N5247AS-01

S E R V I C E

N O T E

N5247AS PNA Series Microwave Network Analyzers

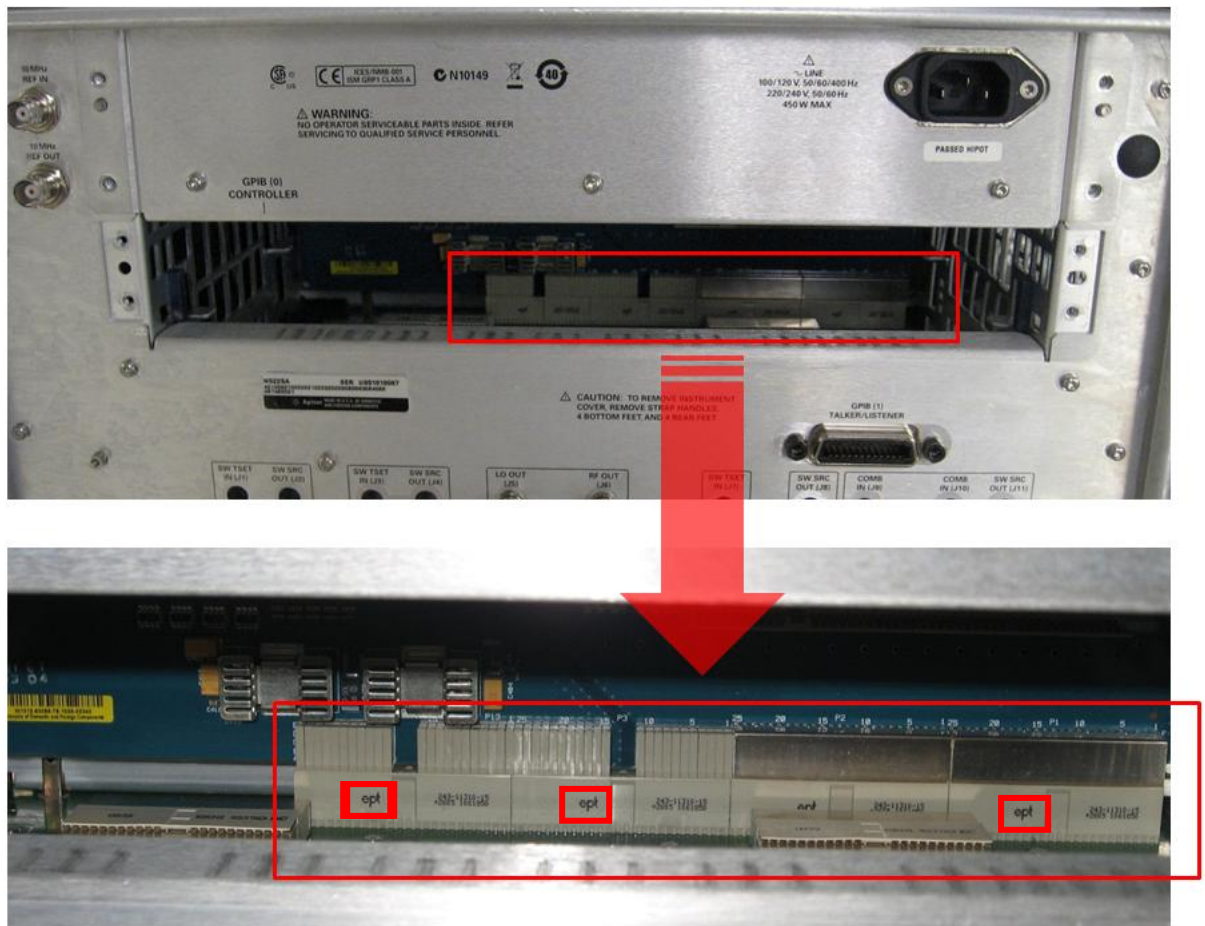
1. Remove the CPU assembly from the analyzer's rear panel. Refer to the PNA Service Guide chapter 7 section titled, "Removing and Replacing the CPU Board Assembly" for removal and reinstallation procedures. To view the online Service Guide, see the numbered list on the next page for instructions.
2. As per the photo below, inspect the system motherboard connector to see if it has one or more "ept" logos.

3. If the connector has one or more “ept” logos, return the analyzer to Agilent for replacement of the system motherboard. If the connector does not have one or more “ept” logos, email support_ctd-soco_support@agilent.com, providing the analyzer model and serial number and details of the malfunction symptoms.

4. *For Agilent Service Technicians only:* Only new boards without “ept” logos should be installed. Before installing the new board, look to see if it has one or more “ept” logos. If so, email support_ctd-soco_support@agilent.com, providing the analyzer model and serial number. Wait for further instructions in an email reply. New boards without “ept” logos can be installed.
For installation instructions, refer to the PNA Service Guide chapter 7 section titled, “Removing and Replacing the System Motherboard.” To view the online Service Guide, see the numbered list on the next page for instructions.
